## M-1.0t MAGNETIC FIELD POWER AMPLIFIER SERVICE MANUAL

**CARVER CORPORATION  
SERVICE BULLETIN**

Service Bulletin # M-1.0t-3

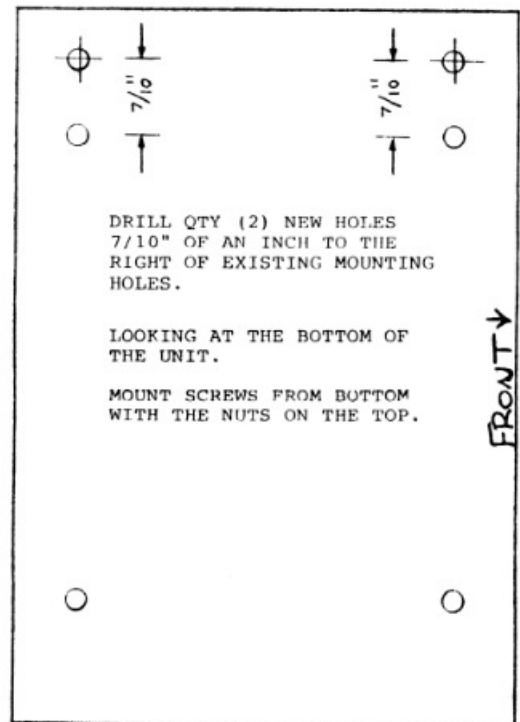
Reason: New Power Transformer being used.

Procedure: When replacing the Power Transformer in the M-1.0t from the original type to the current type, two new mounting holes must be drilled into the bottom sub-panel.

The new Transformer is also wired differently, with the correct connections listed below by terminal number

Delete: Qty (1) NPT-2154 Transformer

Add: Qty (1) 617-10033-01 Transformer  
 Qty (4) 151-20152-00  
           10-32 X 3/8 Phillips Screw  
 Qty (4) 152-10004-00  
           10-32 Kepnut

11	ORANGE	TO P402-4
WHITE FROM	13		
THERMAL SWITCH	12	10	RED TO P401-3
	9	BROWN	TO P402-2
BLACK TO TAP-2	4	8	BLACK TO P401-1
BLACK TO TAP-1	3	7	BROWN TO P402-1
ORANGE-SUPPLY	2	6	RED TO P401-2
BLACK-SUPPLY	1	5	ORANGE TO P402-3

INCORRECT POSITIONING OF TRANSFORMER

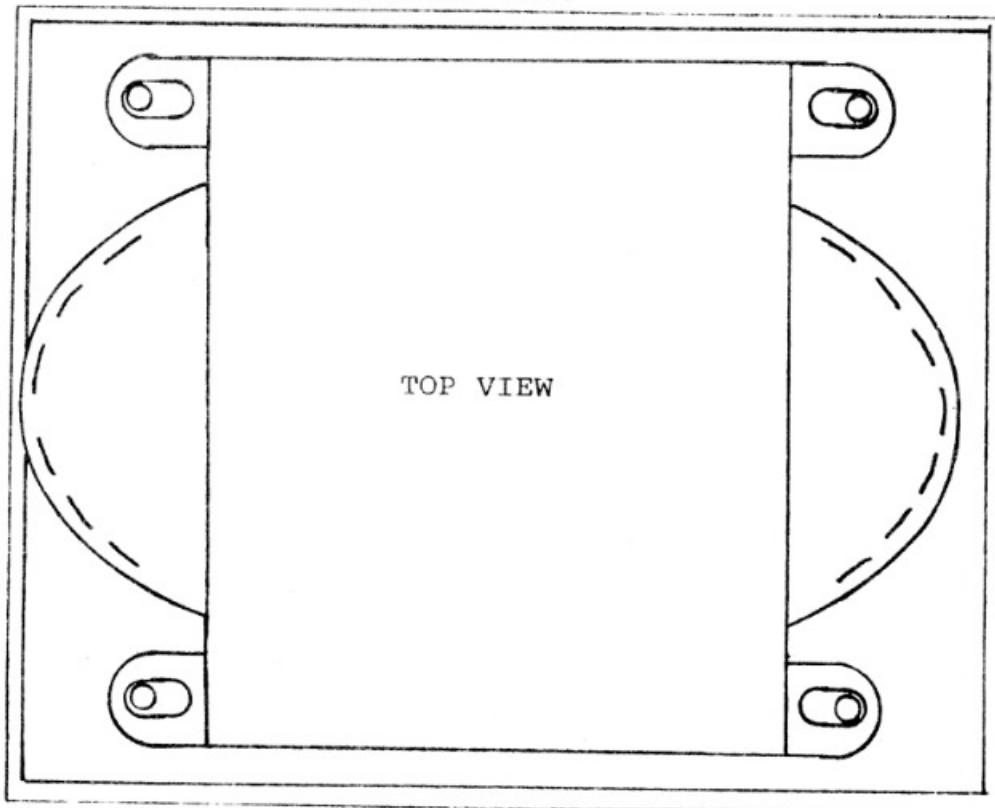
Reason: Power Transformer Primary wires have the potential to short out against the chassis due to the mounting location of the transformer.

- Procedure:
1. Remove screws that hold top cover; remove cover.
  2. Check clearance between the transformer windings and the chassis. This clearance must equal or exceed .050 inches.
  3. If clearance is less than that required, remove the two left mounting screws and relocate the transformer and position to center of mounting plate.
  4. Drill two new mounting holes using the transformer mounting lugs as a guide.
  5. Check for any loose metal shavings; Mount two screws.

Delete: Old serial number, submit with warranty claim.  
CALL SERVICE DEPARTMENT AT 1-800-443-0547 FOR MAILING OF NEW SERIAL NUMBER LABEL.

Add: Insulating Paper 10B-00102-00  
NEW SERIAL NUMBERS

FRONT OF UNIT  
CORRECT POSITION OF TRANSFORMER

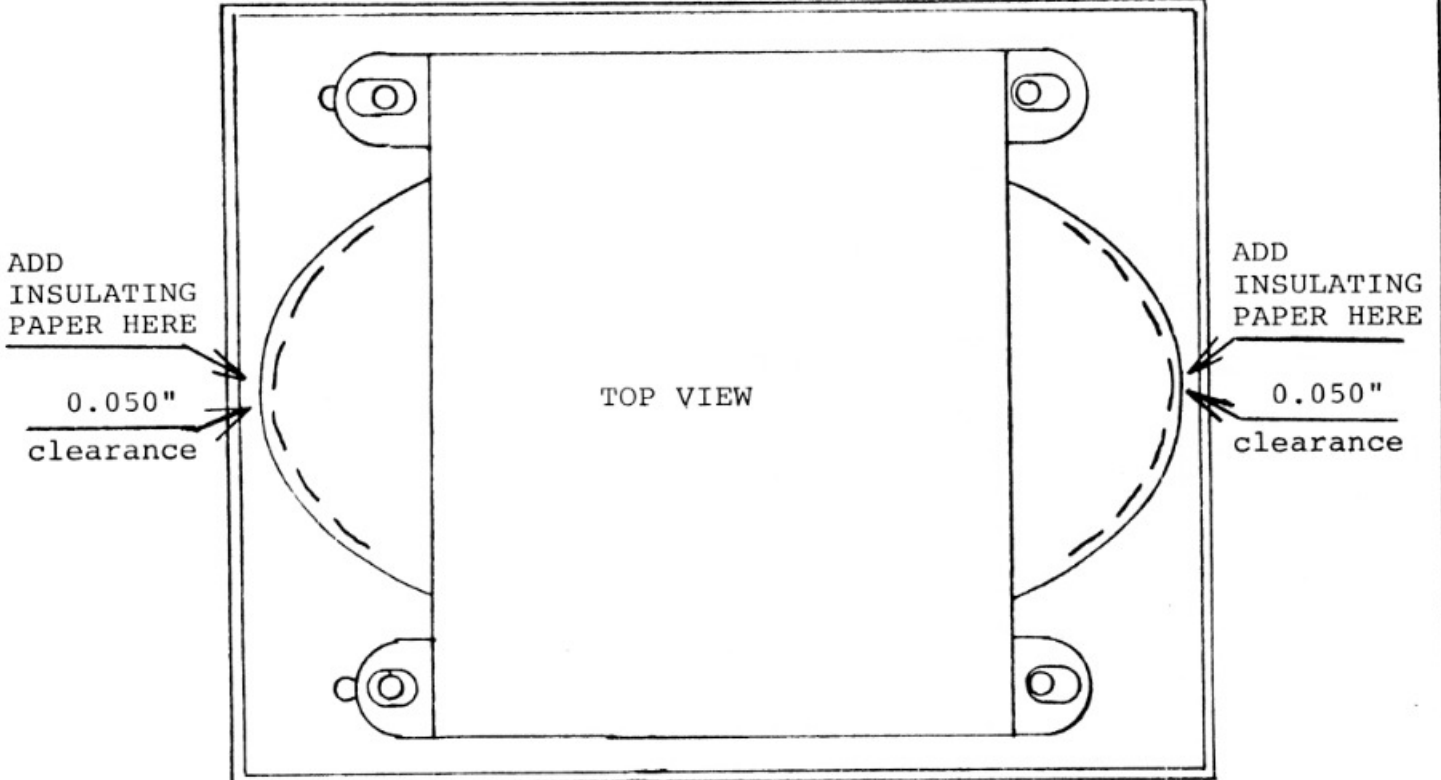
- Procedure: 6. Install (2-1/2)" x (1-1/2)" Insulating paper (108-00102-00) with a 90 degree bend 3/4" from the end of the (2-1/2)" dimension in the left bottom corner of the Transformer mounting pan. The paper is secured on the bottom side with a SMALL amount of RTV (epoxy). This paper is to be used on BOTH SIDES if the clearance on the right side of the transformer is less than .050 inches. SEE BELOW
7. Hi-Pot all units at 1250v.  
8. Function test any units that have had new mounting holes.

POSSIBLE POSITION OF NEW HOLES

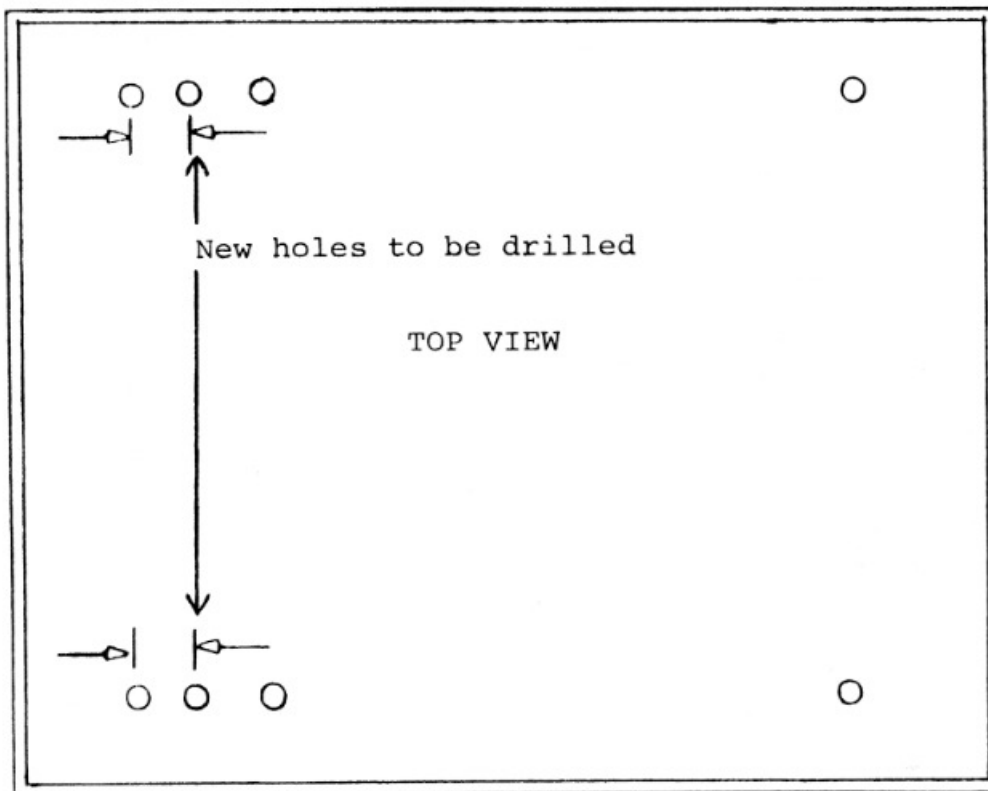
- Procedure: 8. (continued) The function test required is limited to powering the unit up and driving both channels with a signal generator. Check for proper LED movement.
9. Reinstall top cover.
10. FOR WARRANTY CLAIMS AND VERIFICATION REMOVE SERIAL NUMBER AND ADD NEW SERIAL NUMBER LABEL. ( OBTAINED FROM SERVICE DEPARTMENT ).  
SEND IN OLD SERIAL NUMBER WITH WARRANTY CLAIM, THIS MUST BE DONE OR CLAIM WILL NOT BE PROCESSED.

Service Bulletin # M-1.0t-5

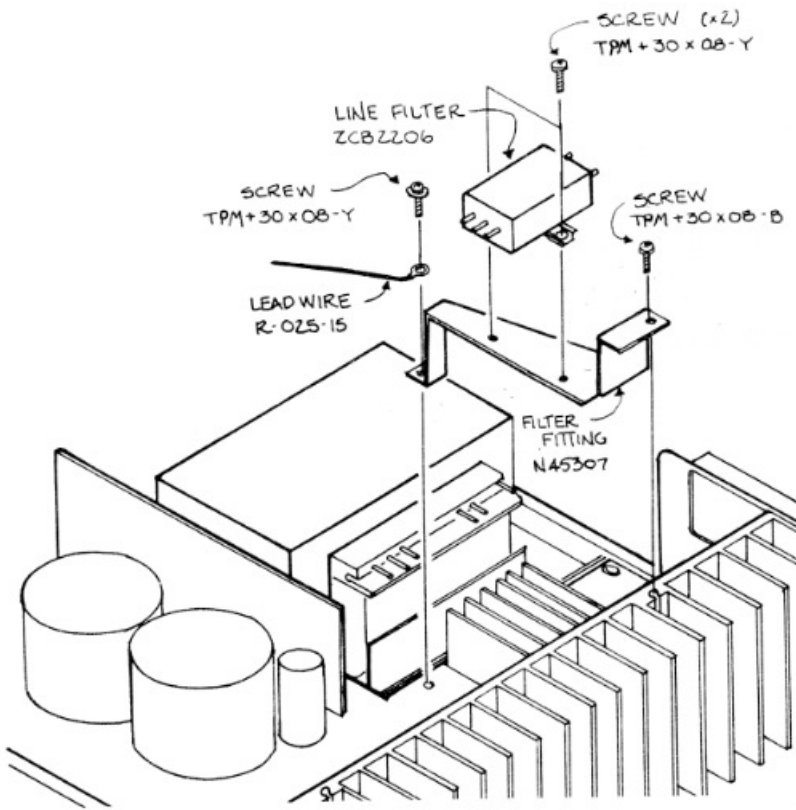
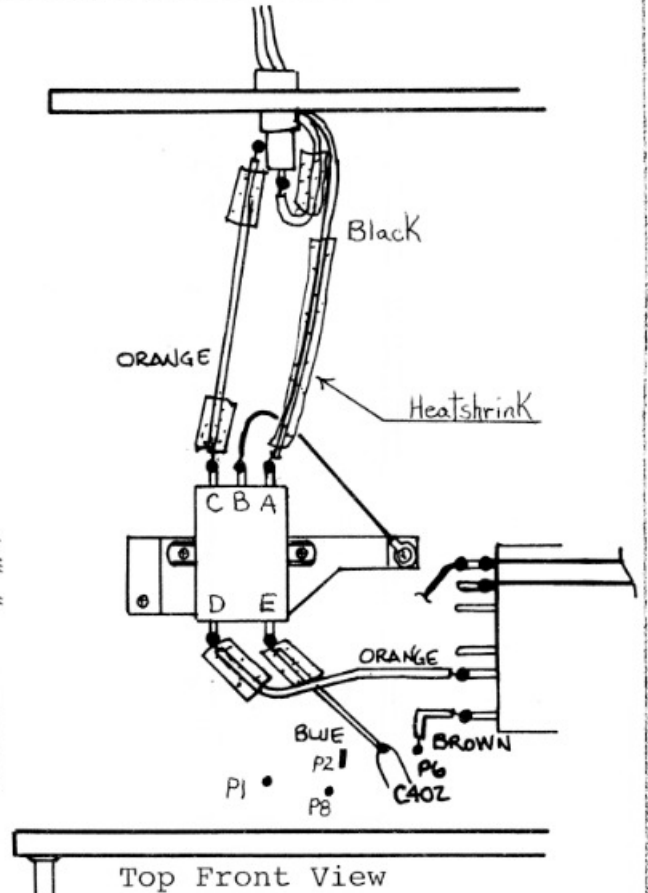
Reason: A.M. interference when amplifier is on.

Procedure: Remove C401, C402, C403 from power supply board.

Remove black wire from P2, cut off 4", solder to tab "A".

Remove orange wire from P8, solder to tab "C".

Remove orange wire from P1, solder to tab "D".

Add blue wire from tab "E" to hole where C402 was closest to C404.

Add black ground wire from tab "B" to ground of chassis.

NOTE: Add heatshrink tubing on wires to filter.

Delete: C401 0.0033uf  
C402 0.0033uf  
C403 0.1uf

Add: ZCB2206-11 Noise filter.  
N45307 Bracket.  
402-10006-00 Heatshrink tubing.  
401-10541-00 22 AWG Blk. 3.5" grd.  
TPM+30X08-Y Qty. (2) Tap screw.  
TPM+30X08-B Qty. (1) Tap screw.  
401-10171-00 18 AWG Blue 3.25"  
111-20051-00 #6 solder lug

Fig. 1.

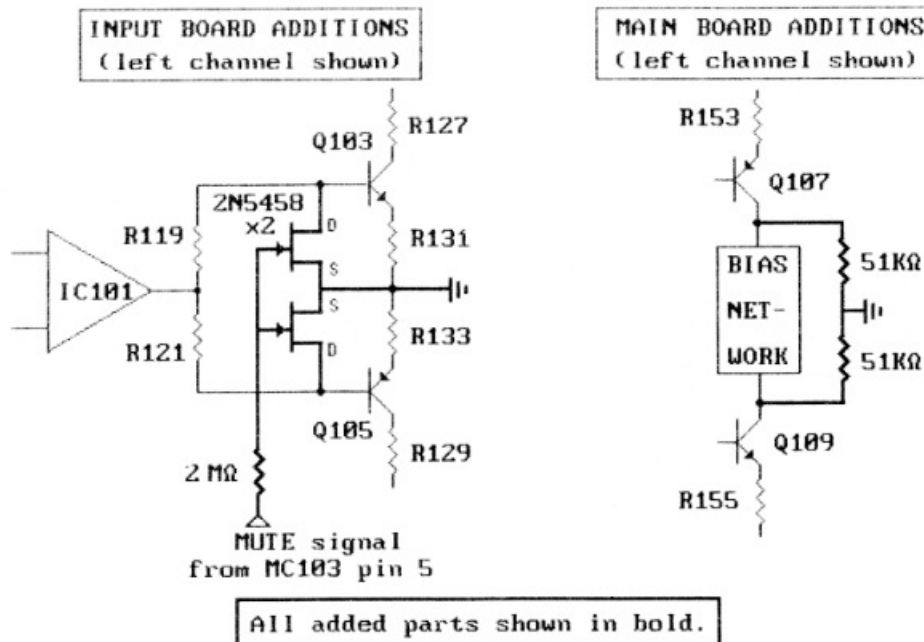
**Note:** Turn-off thump in excess of 2 volts p-p may indicate unbalanced  $\pm 12V$  supplies, leaky input op amp IC101, or shorted commutator transistor. Check these components before proceeding.

1. Remove input board and install FET's and 2 M $\Omega$  resistors as indicated in Fig. 2 and 3. All components must be installed on the foil side of the board. Re-install board.
2. Install 51 K $\Omega$  resistors on the foil side of the main board as indicated in Fig. 4 and 5.
3. Power up amplifier and test performance. Turn-off thumps should be less than 200 mV into 8 $\Omega$  dummy loads. May be monitored on DC coupled scope set to slowest sweep setting.

Qty. 4	321-40005-00	(2N5458 FET)
Qty. 4	251-00111-00	(51K $\Omega$ $\frac{1}{4}$ watt)
Qty. 2	251-00149-00	(2M $\Omega$ $\frac{1}{4}$ watt)
